# JEFFERSON PARISH

### ADDENDUM # 1

Bid Number: 50-00147989

### Purchase of a Vertical Turbine Pump for the Jefferson Parish Department of Sewerage

# Attachment "A"

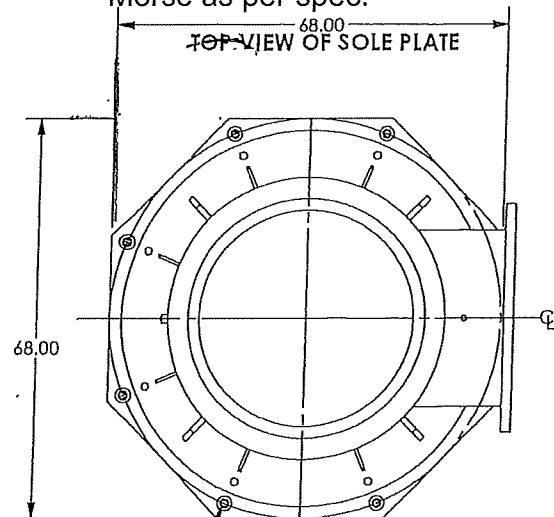
1. **QUESTION:** Please supply a general arrangement drawing of the existing Fairbanks Morse model 36G, 1 stage pump. The bid documents are not complete without a drawing of the existing pump.

**ANSWER:** Please See Attachment "A"

REV1. M11 PE HARNESS DISCHARGE REPLACED WITH 30" FLANGED DISCHARGE  
REV2. SOLE PLATE CORNERS WERE 17 X 17 TITLE BLOCK DESCRIPTION SAID P.E.
